Access Compliance Report

Public Rights-of-Way

(Pedestrian Signals)

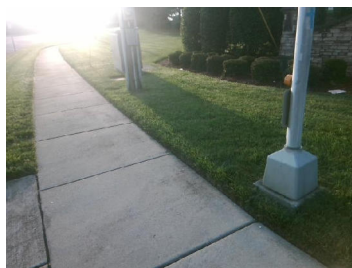
Surveyor Notes: TEXT HT 7/16

PROW/ADA: R410.6, TMUTCD 4e.08, R404.7.3

Possible Solutions: Replace Signal Push Button With APS Button on New Post. Remove & Replace Sign.
